VX1000

Antenna Change

VX1000 R&D Team

Nov 09, 2005

VX1000 Antenna Change

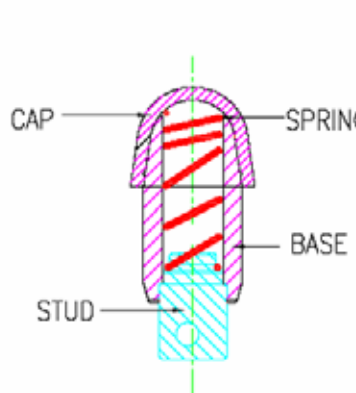
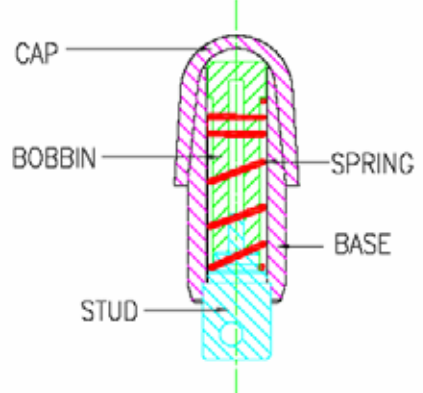
CHANGES	IN DETAIL Please refer to pictures in right side	BEFORE (H/W 1.0)	AFTER (H/W 1.1)
ANTENNA SHAPE	Externally, antenna shape is changed.		
INTERNAL STRUCTURE	The main reason which antenna is changed is extended BOBBIN size in antenna. (Antenna length: 4 mm ↑)		
MATCHING CIRCUIT	Matching circuit is changed like beside pictures.		
EMI COATING	Different coating method	Spray Coating	Evaporation Coating
